Status: Y N U **Seismic Walkdown Checklist (SWC) SWEL1- 075**Equipment ID No. M71N026A Equip. Class¹ 19 - Temperature sensorsEquipment Description Temperature Element (Suppression Pool)Location: Bldg. CTMT Floor El. 135 Room, Area 1A311, CTMTManufacturer, Model, Etc. (optional but recommended) Thermo Electric, 27620**Instructions for Completing Checklist**

Seismic Walkdown Checklist (SWC) SWEL1- 075

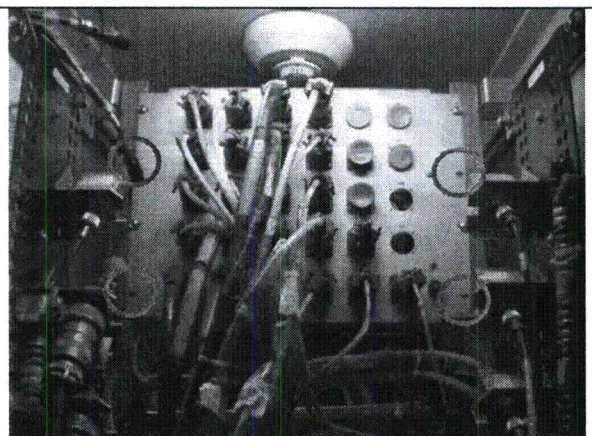
Note: Missing screws (Bay A)

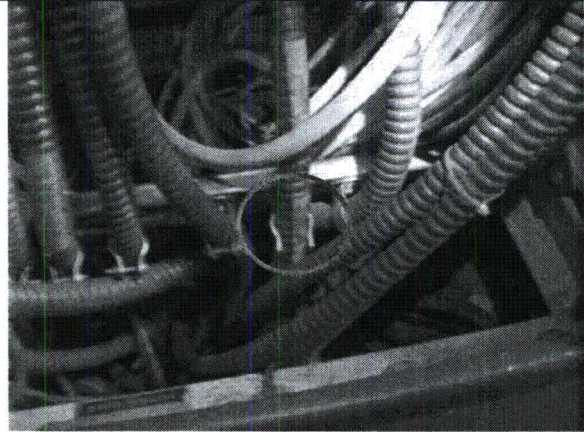
Note: *Nut not fully engaged to the threaded stud*

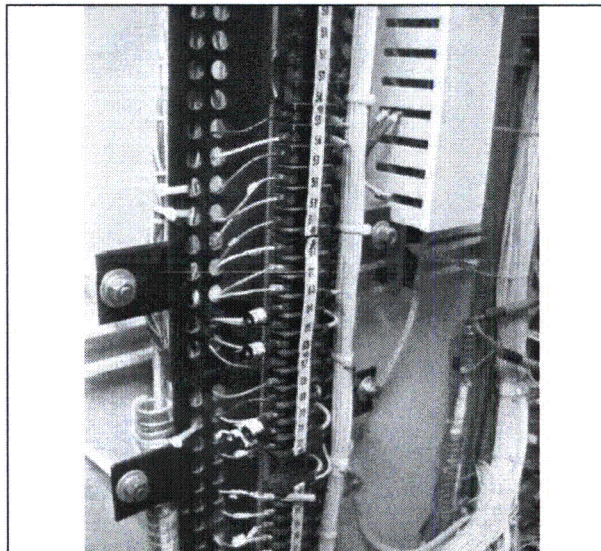
Note: Missing nut (not shown) on mounting bracket for cable bundle support

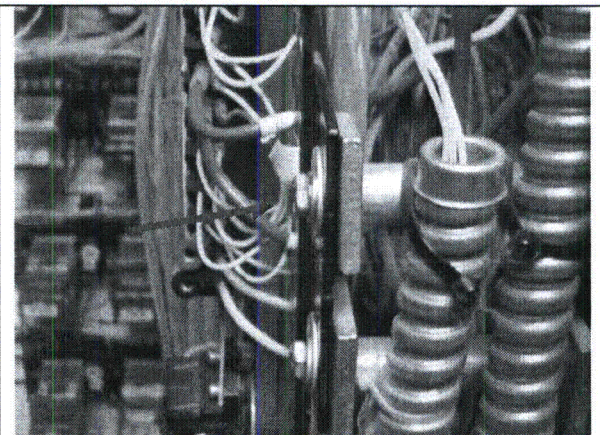
Note: Nut not fully engaged to the threaded stud

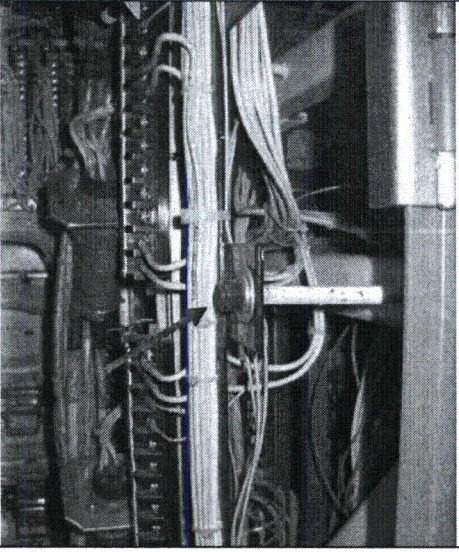
Note: Nut not fully compressed

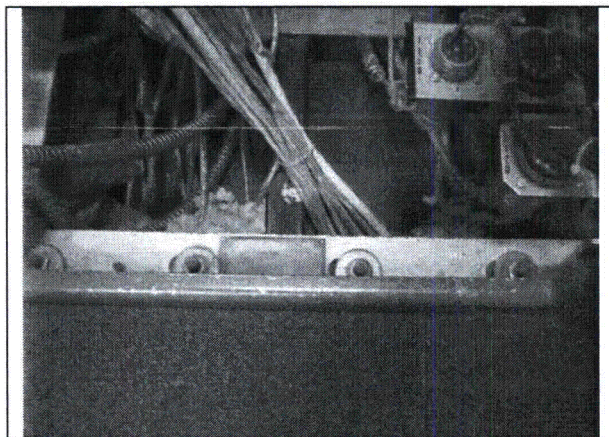
Note: Inside of the panel, plastic bag left inside

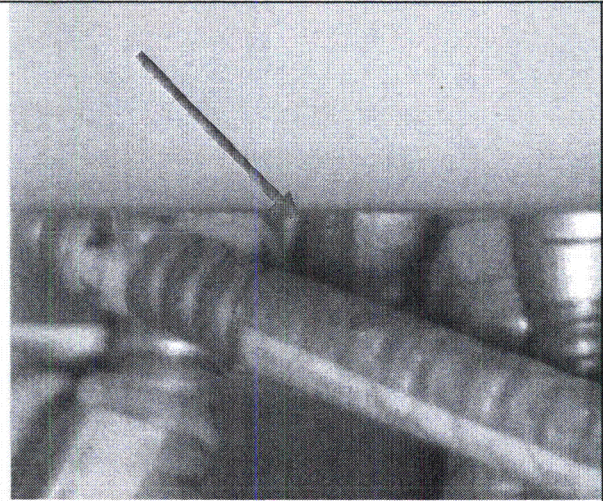
Note: *Missing nut and washer.*

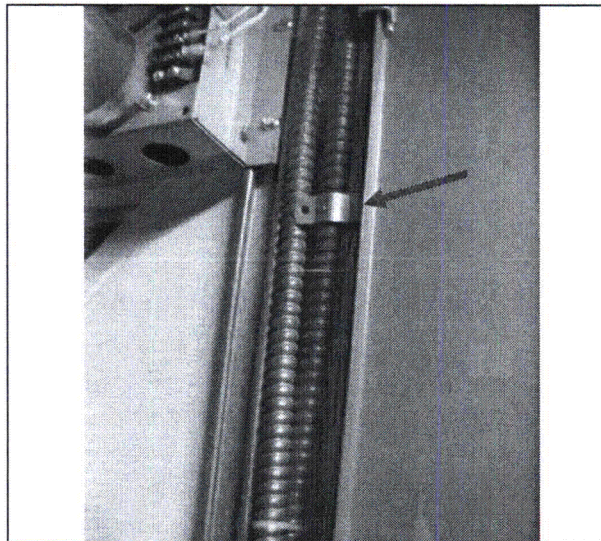
Note: Missing bolt and nut on clamp

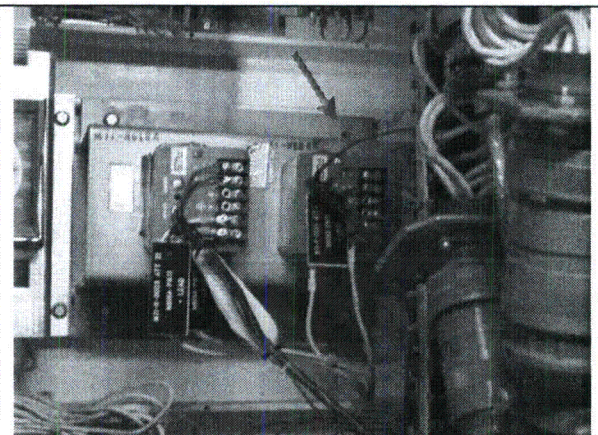
Note: Missing bolt on mounting bracket for M71N606A & M71N616A

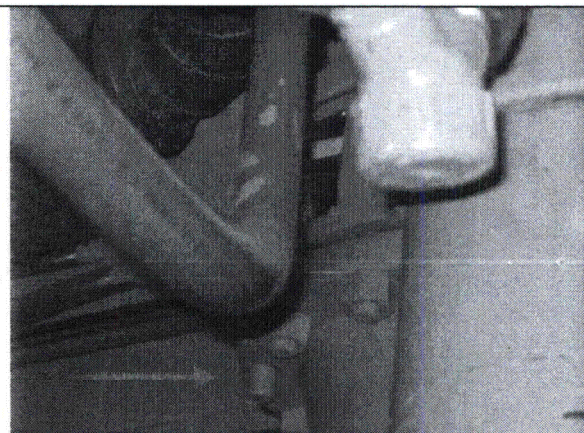
Note: Missing nut on valve G41F045

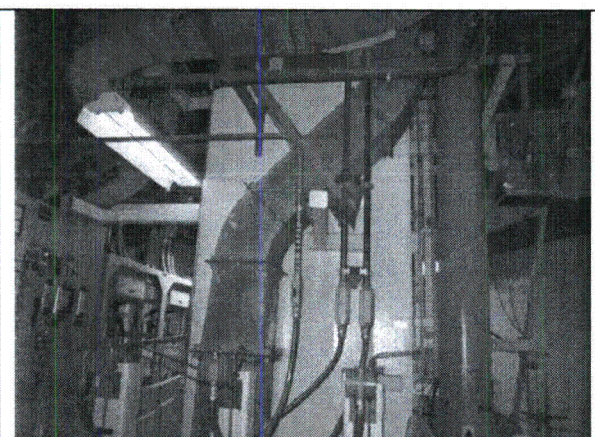
Note: *Loose bolt*
